GE Nuclear Energy

MFN 050-96
Docket No. 52-001

ABWR Design Change Assessment Review of FOAKE Design Changes

PROPOSED CHANGES

FIGURE 9.4-1 CONTROL BUILDING HVAC FLOW DIAGRAM (Sheet 1 of 5)

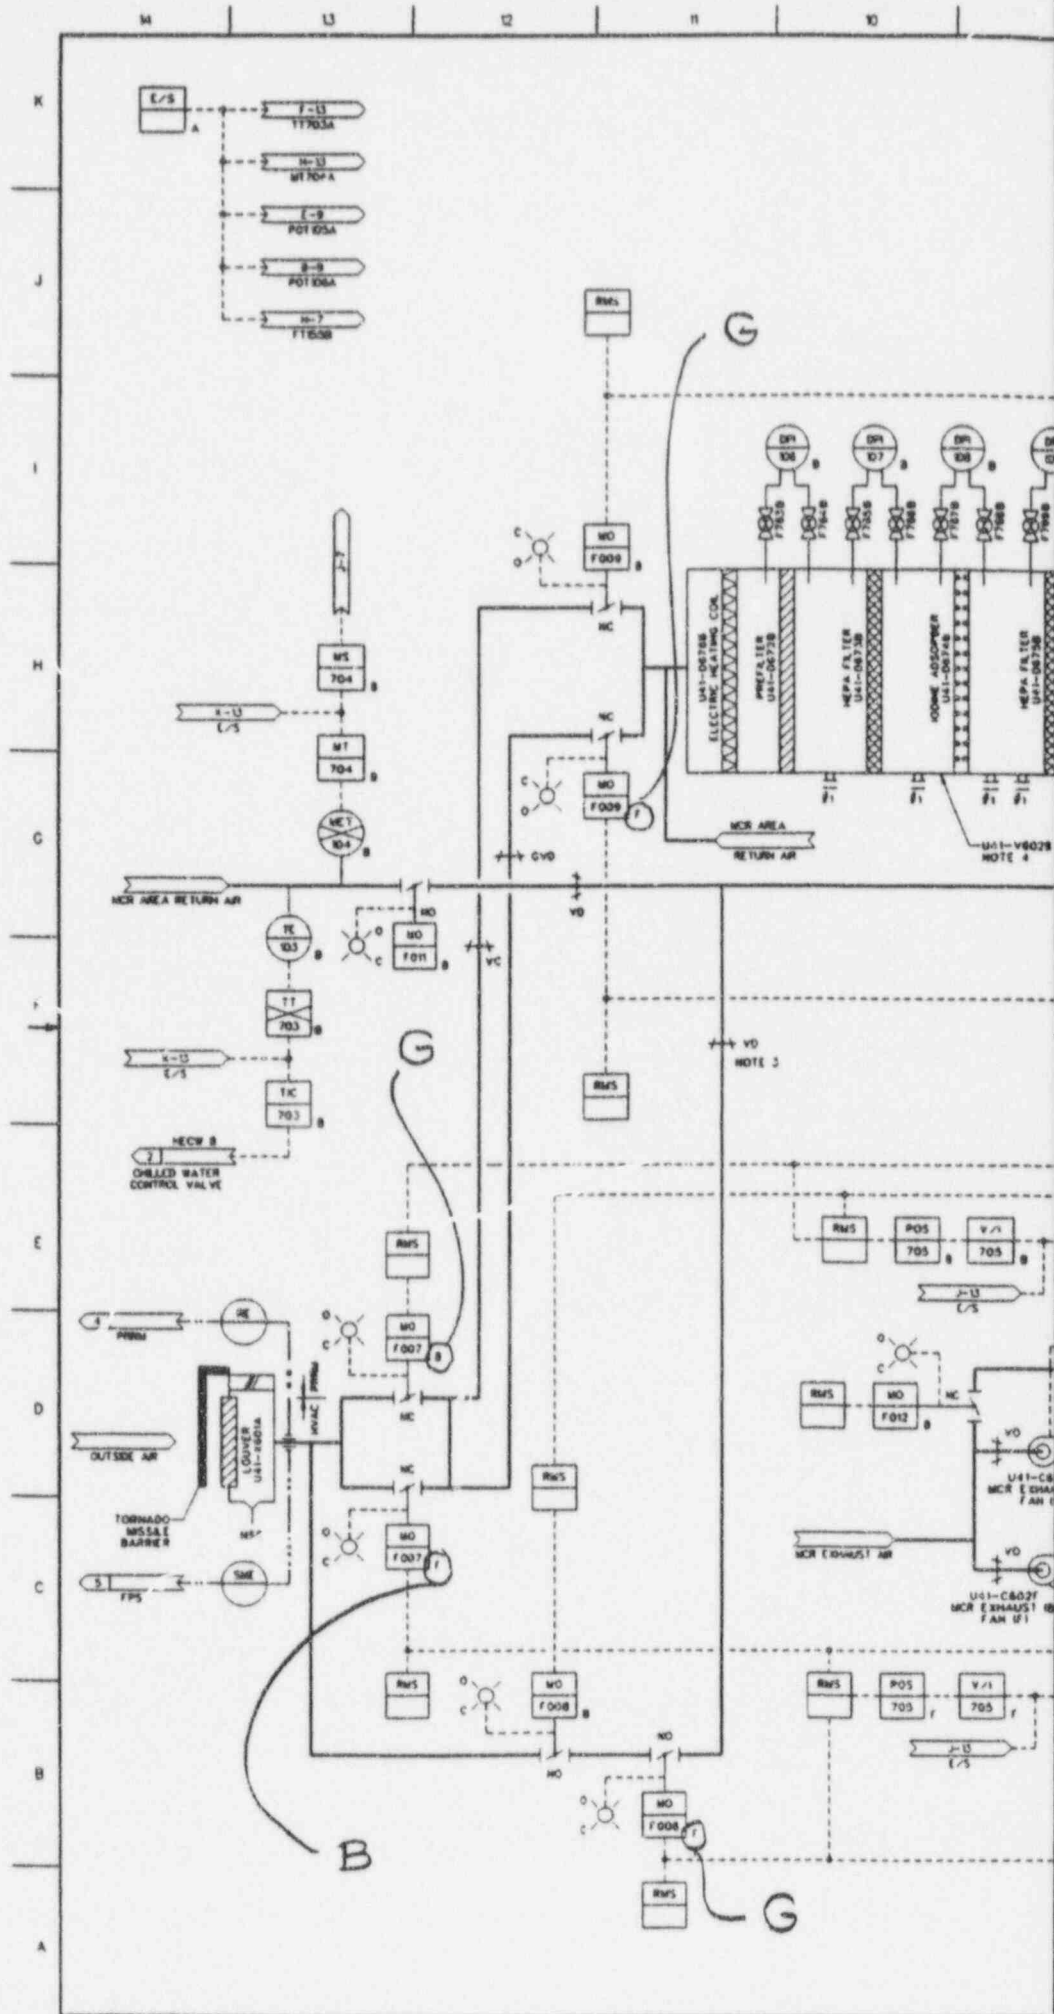
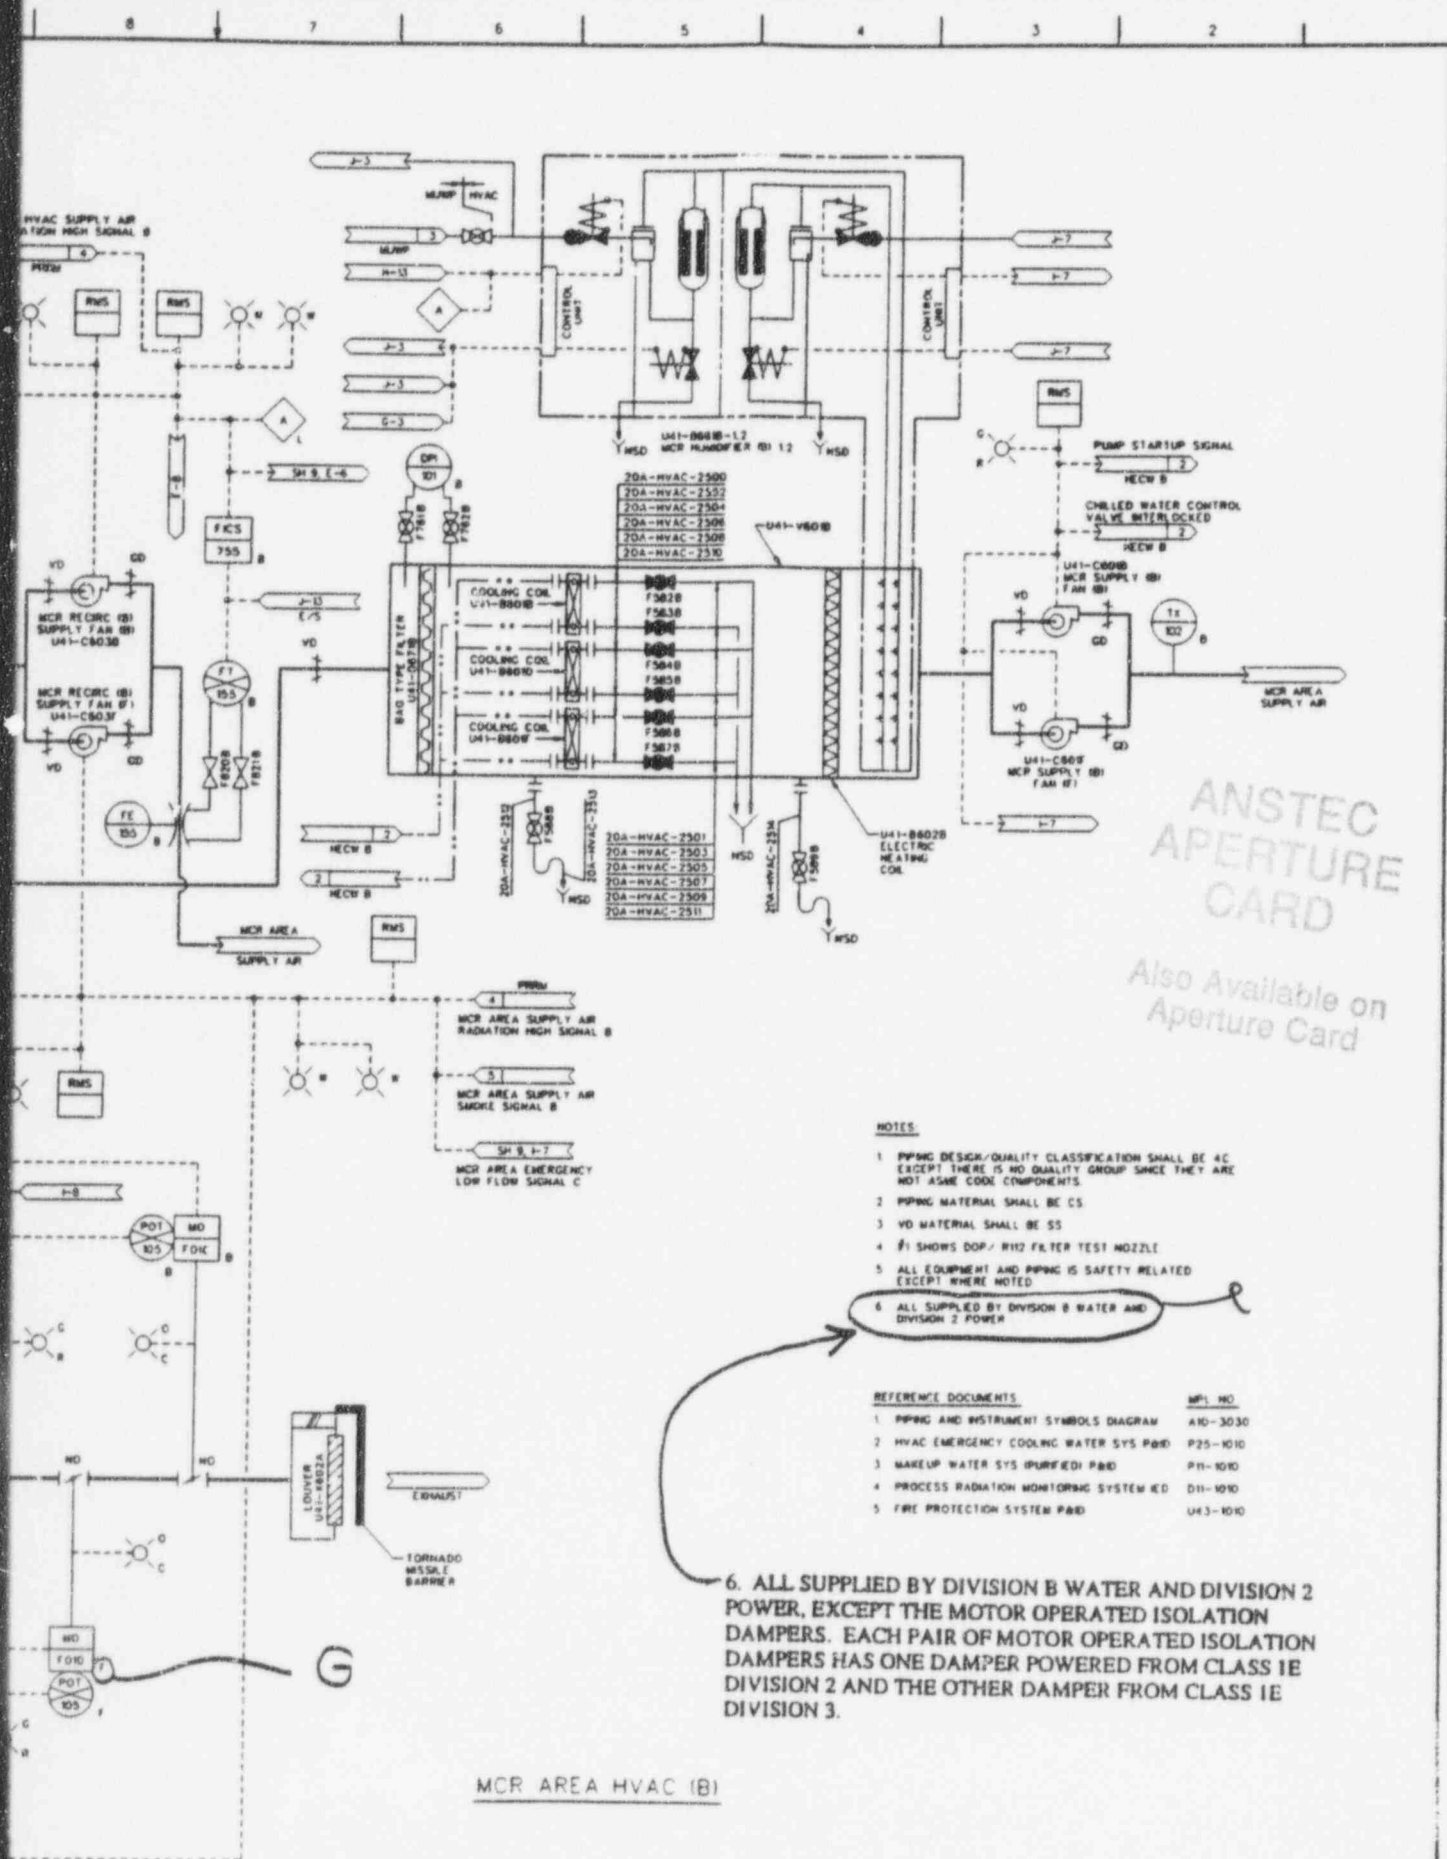
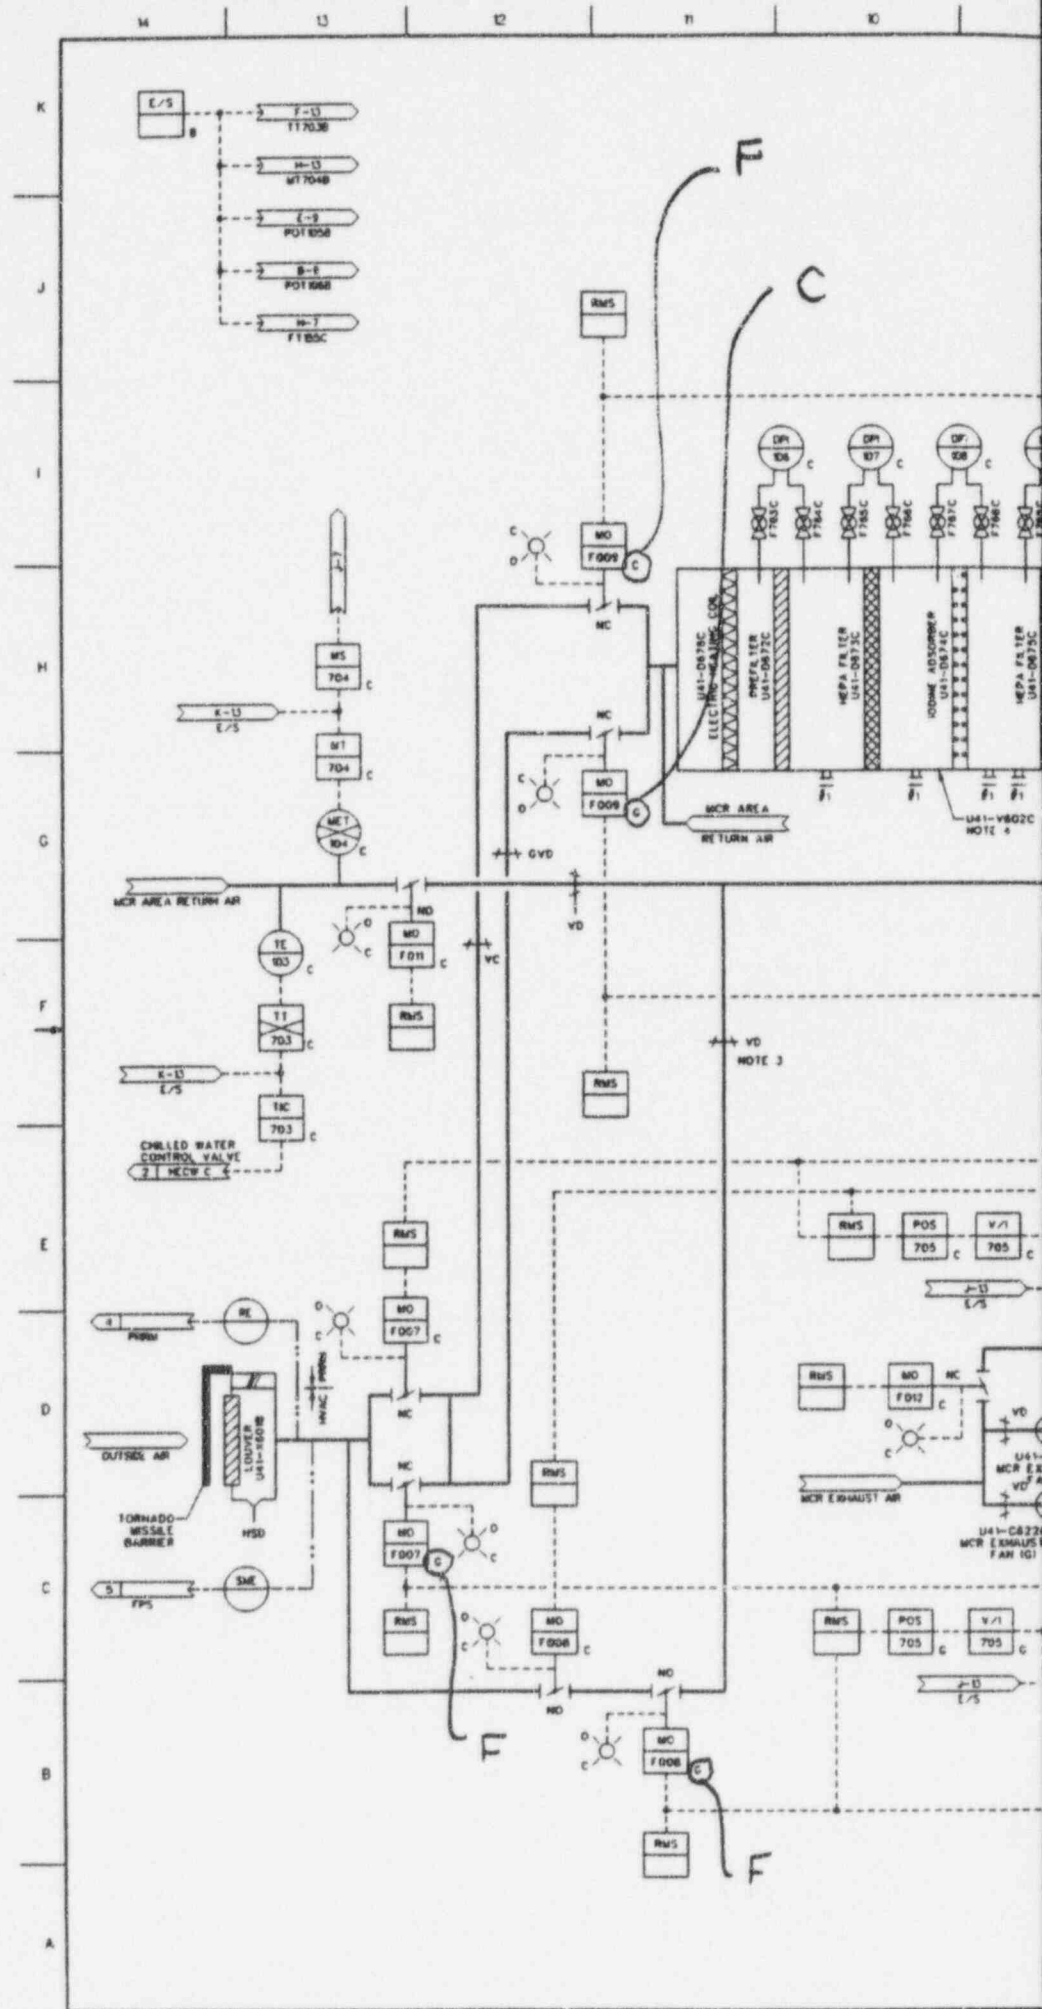
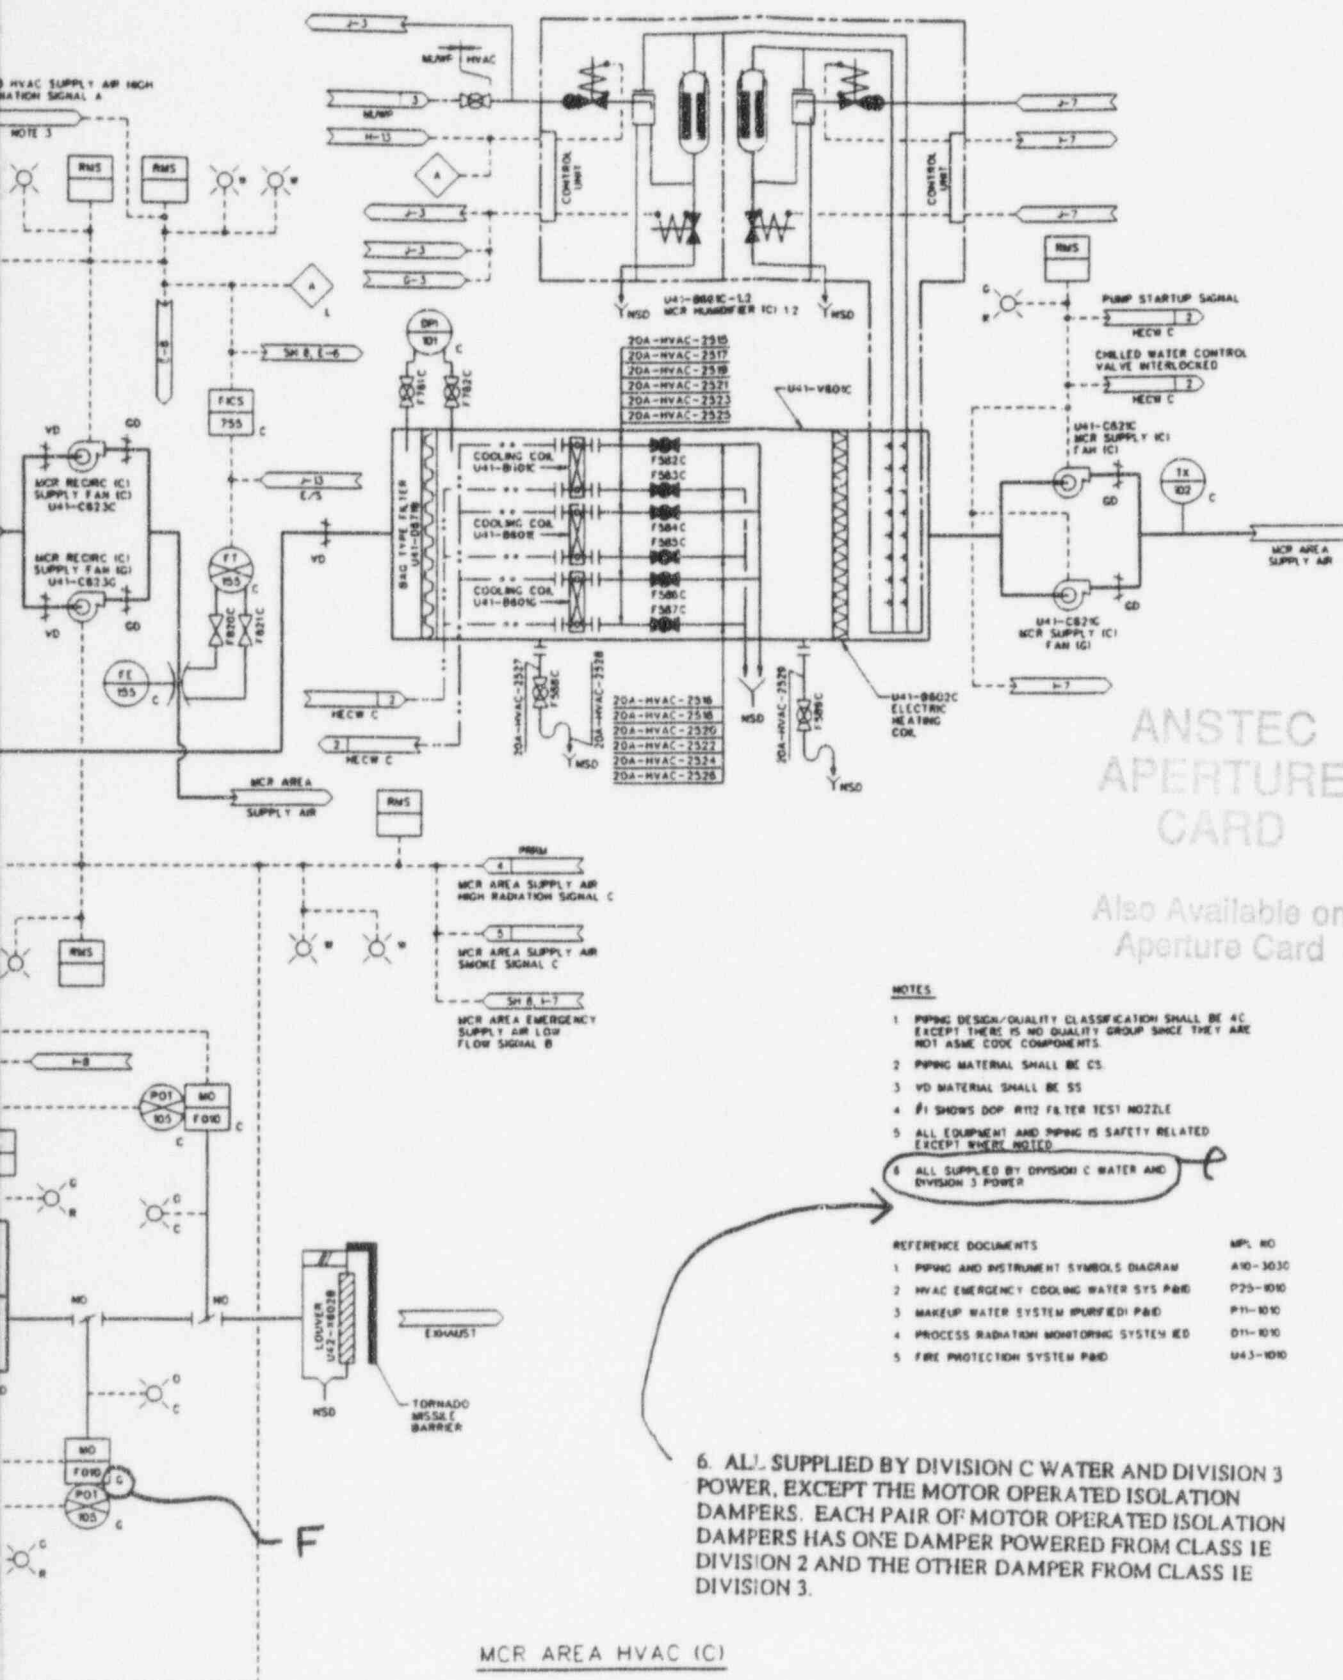
← ADD

FIGURE 5.4-B REACTOR CORE ISOLATION COOLING SYSTEM P&ID (Sheet 3 of 3)
 ABWR DCD/Tier 2 Rev. 0 21-100

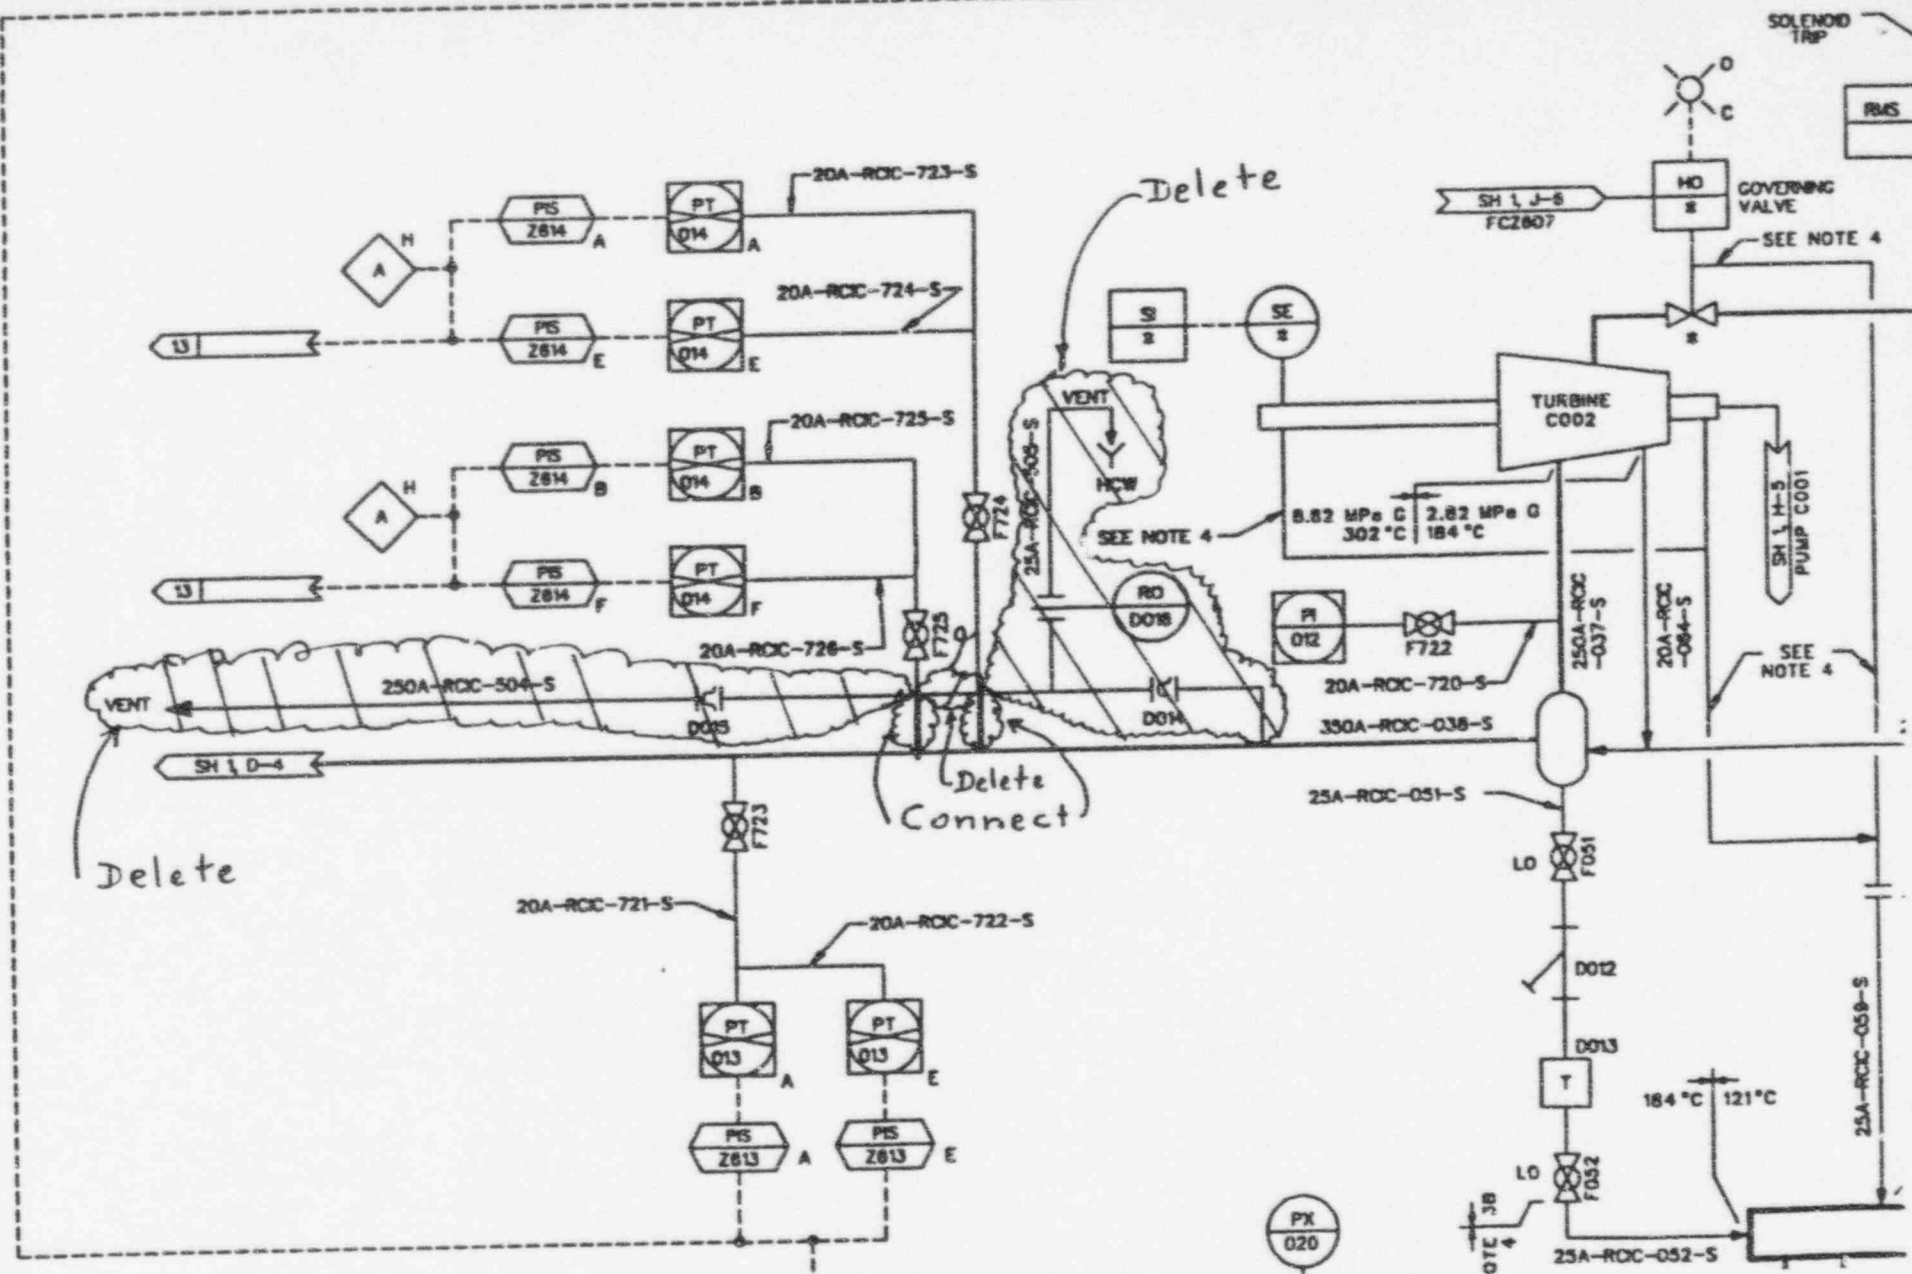
Reference	Components	Press./Temp./Design/ Seismic Class	Remarks
Sheet 3	250A-RCIC-037-S Pipe	2.82 MPaG, 184°C,3B,As	Was 0.981 MPaG
	20A-RCIC-720-S Pipe	2.82 MPaG, 184°C,3B,As	Was 0.981 MPaG
	20A-RCIC-F722 Valve	2.82 MPaG, 184°C,3B,As	Was 0.981 MPaG
	20A-RCIC-PI012 P.Ind.	2.82 MPaG, 184°C,3B,As	Was 0.981 MPaG

Replace all four with "8.62"
Replace all four with "302"
